**Report to the Secretary on an application for a Site Compatibility Certificate.
State Environmental Planning Policy (Housing for Seniors or People with a
Disability) 2004**

SITE: The subject land is at the corner of Sark Grove and Pembroke Road, Minto (Lot 1 DP 620265) and has an area of approximately 5.88ha. The site is bounded by Sark Grove to the north, Townson Avenue to the east, Pembroke Road to the west and McBarron Creek to the south.

PROPOSAL: The site compatibility certificate (SCC) application (**Attachments F1–F11**) seeks to enable the development of a seniors housing village at the site.

Figure 3: Land zoning map extract.

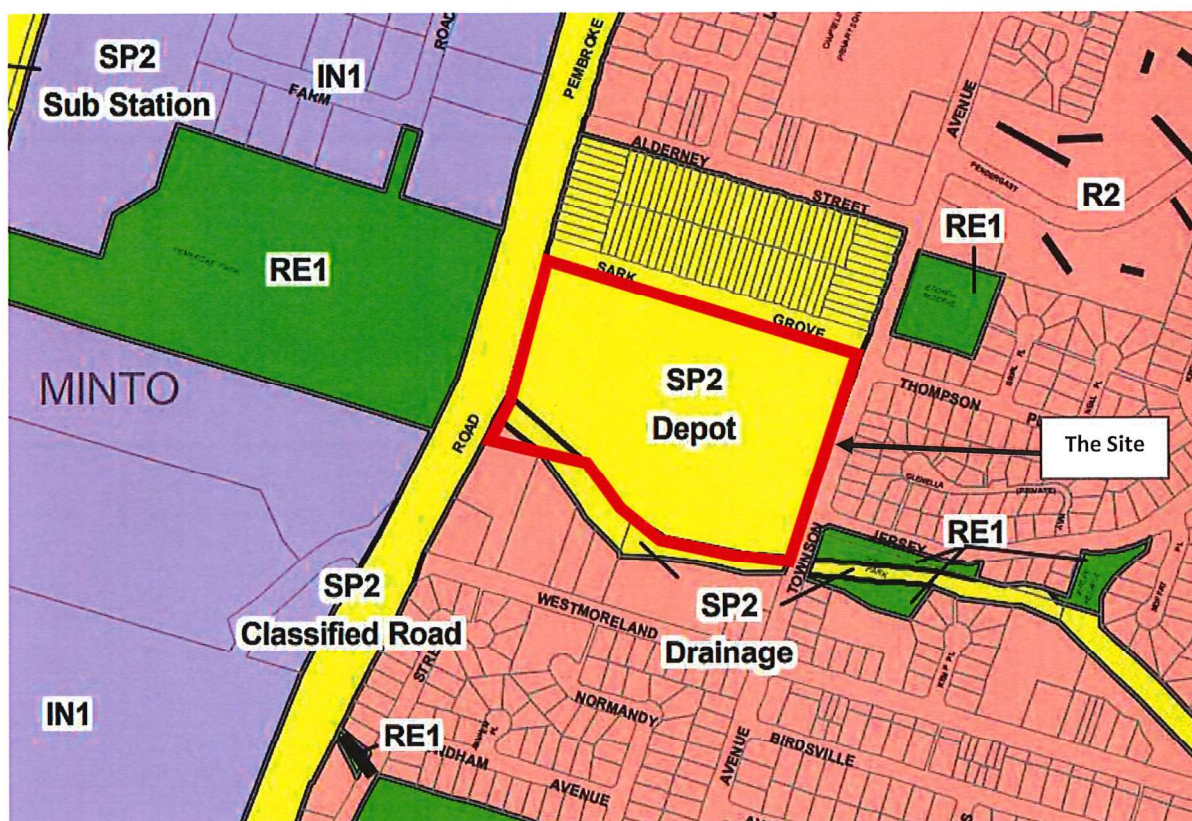
The land is predominantly zoned SP2 Infrastructure (Depot) with a small portion of SP2 Infrastructure (Drainage) and R2 Low Density Residential-zoned land under the Campbelltown Local Environmental Plan (LEP) 2015 (Figure 3). Seniors housing is not a permitted land use within the SP2 zone.

Figure 5: Existing vegetation on the site and proposed vegetation removal.

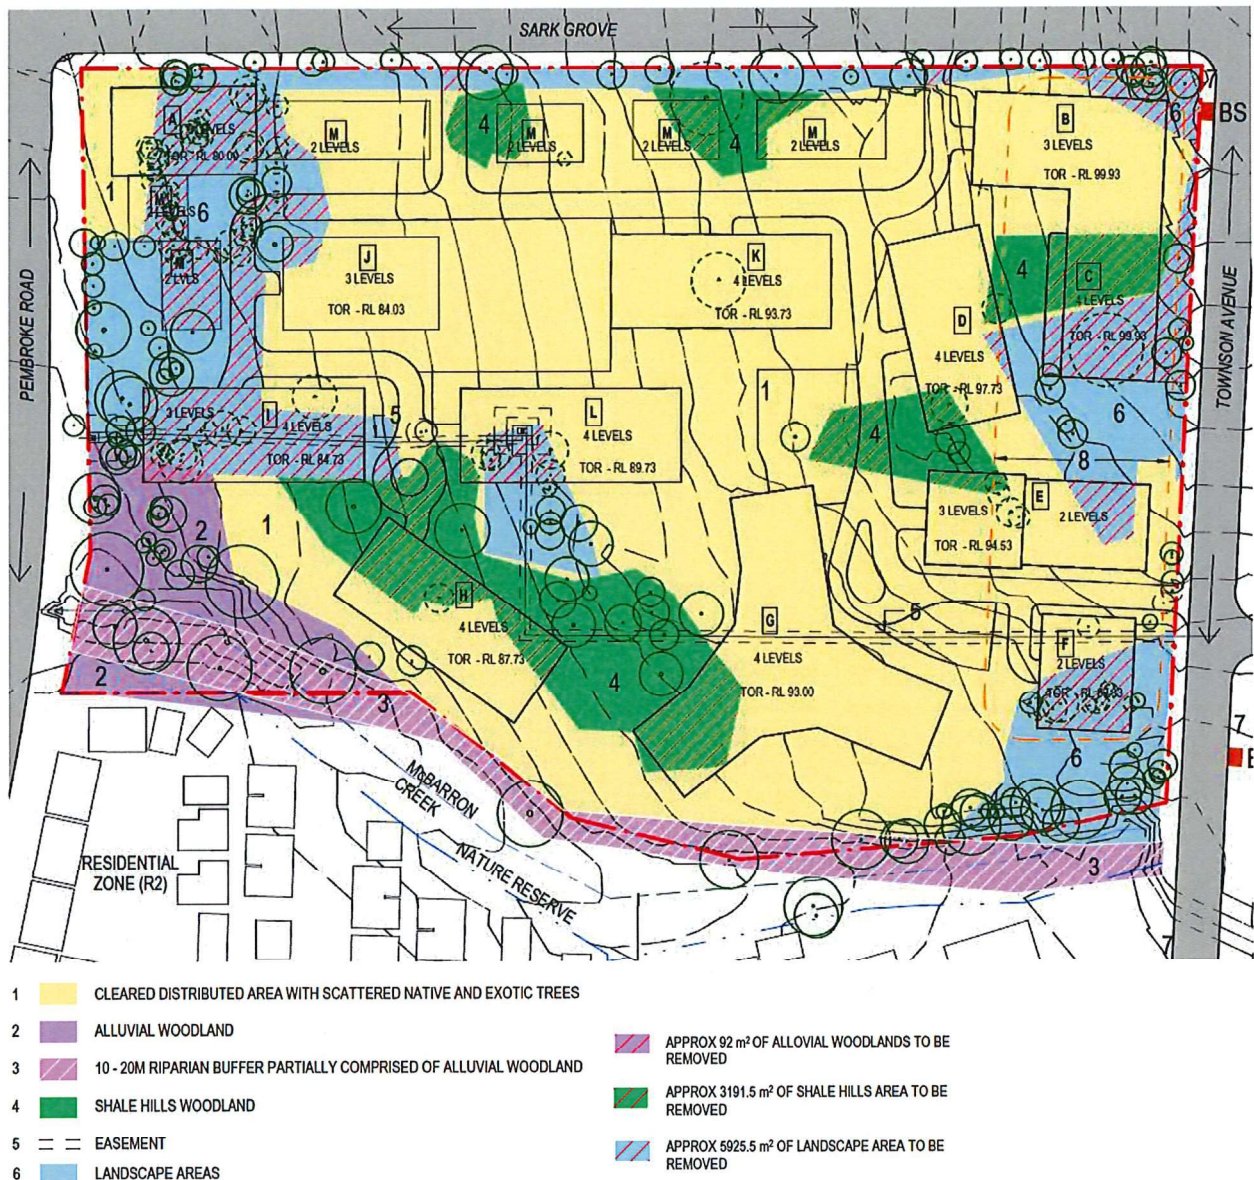
The ecological report notes that while the condition of the two ecological communities is very low, their conservation significance is high.

The proposed development will remove approximately 92m² of Alluvial Woodland, 3191.5m² of Shale Hills Woodland and 5925.5m² of landscape area from the site (**Attachment F10**). It is recommended that the SCC includes a requirement to consider alternative design options to minimise the removal of the Shale Hills Woodland and Alluvial Woodland, where possible.

It is recommended that the SCC for seniors housing includes a requirement for a 10m riparian corridor and 10m setback for the proposed development. This will ensure that a link is maintained between the existing open space in the area.

Figure 6: Contaminated area on the site (area in pink).

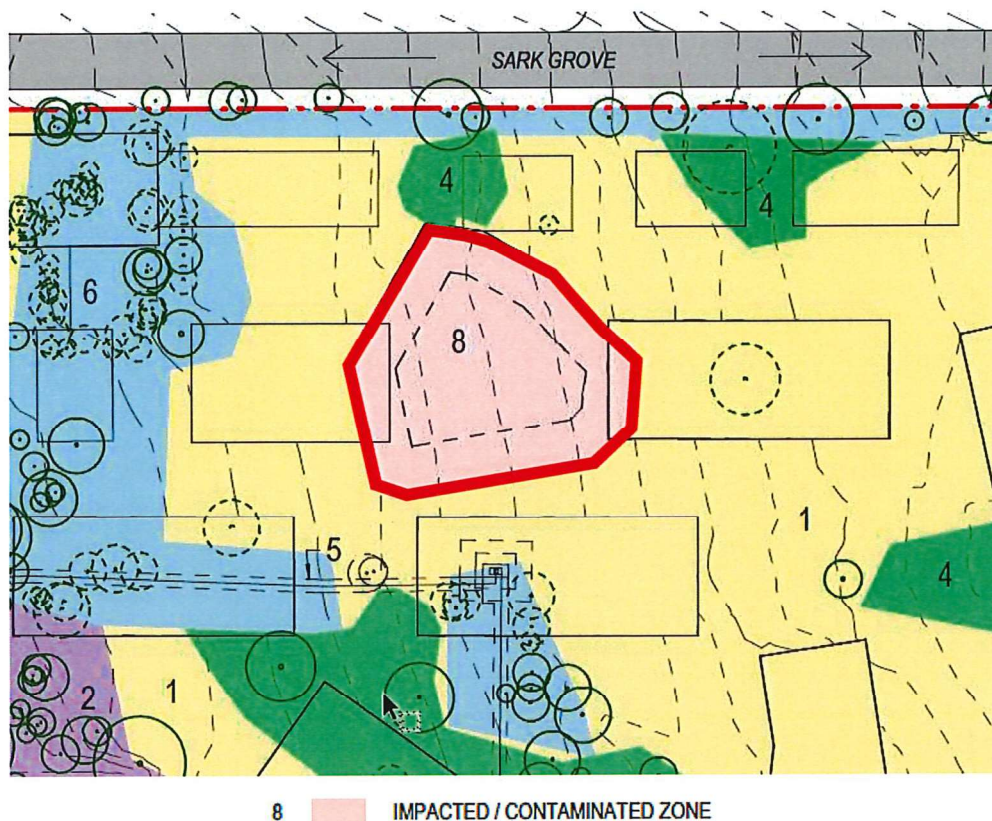
The report concludes that health risks to residents or workers who occupy future multi-storey residential or mixed-used buildings within the impacted zone are potentially unacceptable. However, risks to future users of a low and medium-density residential development, construction and intrusive maintenance workers, or users of outdoor areas are low and acceptable.

The report found that any building with a slab less than 15m in diameter will have a low and acceptable risk. One or two-storey residential development with slab diameters of greater than 15m, which does not contain basements or lifts in the impacted zone, poses a low and acceptable risk. A building with a slab greater than 15m in diameter that has more than 1-2 storeys or has a lift/basement may have unacceptable risks. The proposal (**Attachment F2**) states that the proposed buildings on the impacted zone have a slab of less than 15m into the impacted zone and as such there is a low and acceptable risk.

It is recommended that the SCC includes a requirement for the provision of an updated contamination report for the proposed development. This will address Council's concerns and provide clarification of the contamination risk for future residents and necessary remediation requirements.

Figure 7: Slope constraints on the site.

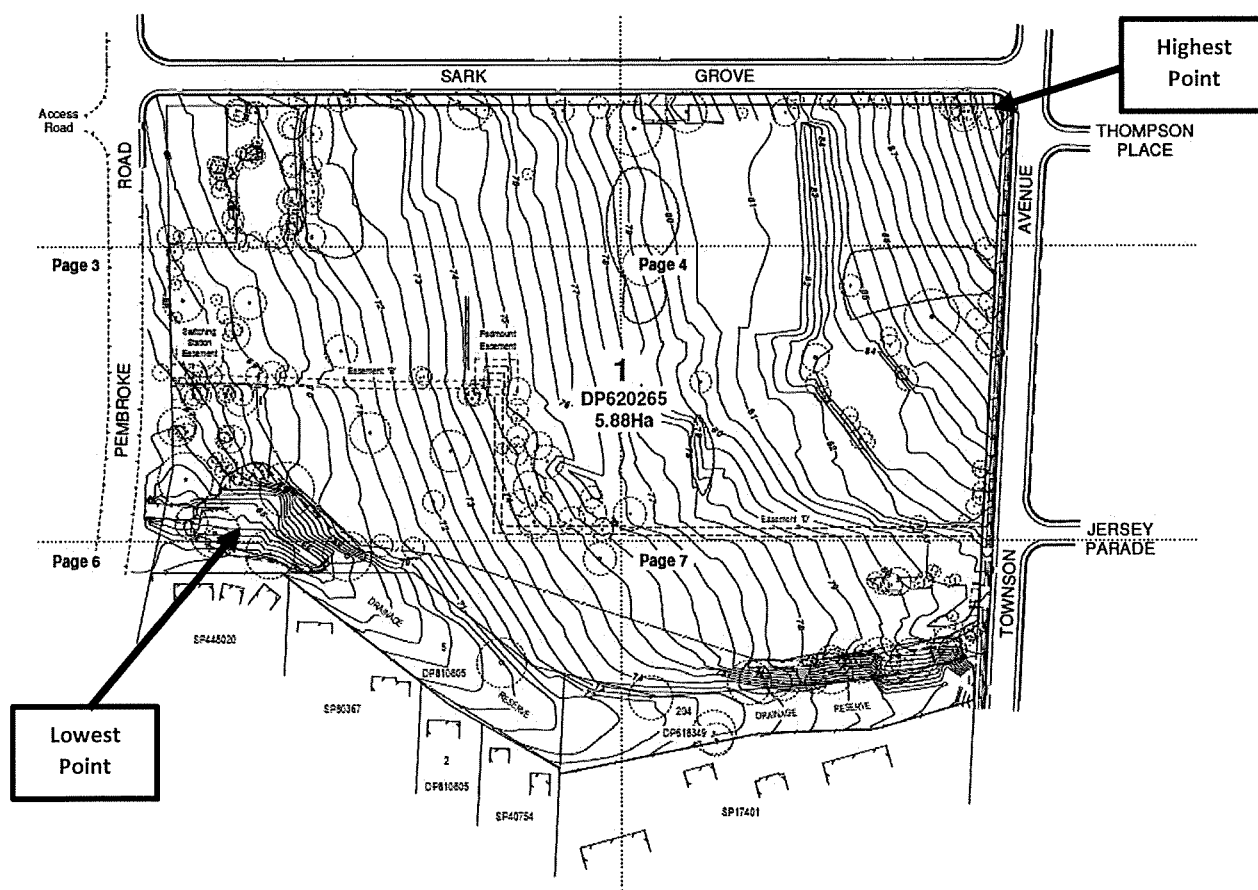
The site slopes from east to west and north to south, with the high point of the site towards the corner of Sark Grove and Townson Avenue (Figure 7, next page). The highest point of the site is RL 91.17 at the north-eastern corner and the lowest point of the site is RL 67.48 at the south-western corner.

The proponent notes that the gradients along the western portion of the site are between 1:25 (4%) and 1:40 (2.5%) and paths will be provided adjacent to roads reflecting a similar grade (**Attachment F11**). The eastern portion of the site is steeper and future residents will be able to access the northern bus stops along Townson Avenue via a lift in Building B, which will be located at the corner of Sark Grove and Townson Avenue. The residents will be able to enter Building B at ground level at the western side of the building and will exit the lift at the piazza level, which relates to the ground level at Townson Avenue.

The proponent also notes that the gradients to the southern bus stop along Townson Avenue will be similar to the western portion of the site. The path will vary in gradient from 1:25 (4%) and 1:30 (3.3%).

It is recommended that the SCC includes a requirement for the provision of access arrangements, consistent with the SEPP, to Townson Avenue for all residents on the site. This will ensure that access from the site to public transport facilities meets the requirements of the Seniors Housing SEPP.

Figure 8: East-west elevation extract.

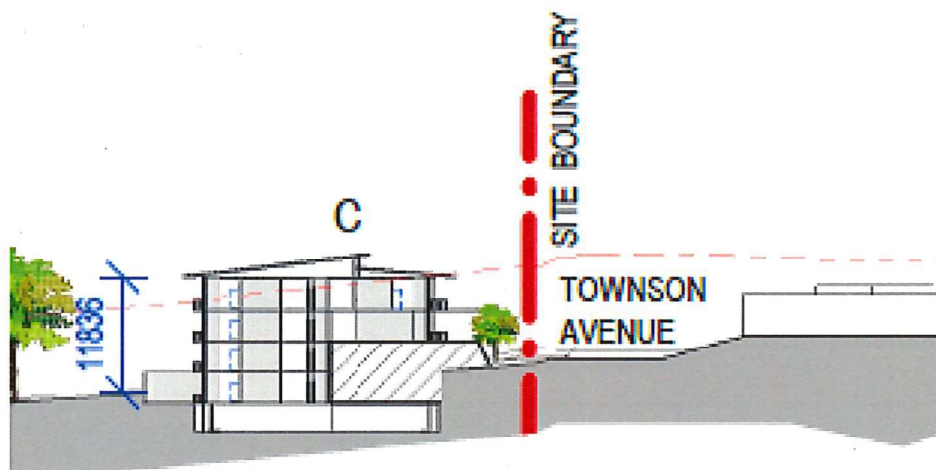
Although three and four-storey buildings are proposed fronting Townson Avenue (the highest point of the site), it is noted that these buildings will sit lower than the existing ground level due to the slope and will present a two and three-storey scale frontage to Townson Avenue (Figure 8, next page). It is advised that the lower scale (up to 12m) buildings along this frontage will provide an appropriate transition between the

one and two-storey dwellings on the opposite side of Townson Avenue and the larger three and four-storey buildings within the site.

It is recommended that the SCC includes a requirement for an appropriate scale for buildings interfacing the low-density residential development along Townson Avenue to minimise the visual impact along this street frontage. Therefore, the development outcome would be a two-storey interface along Townson Avenue.
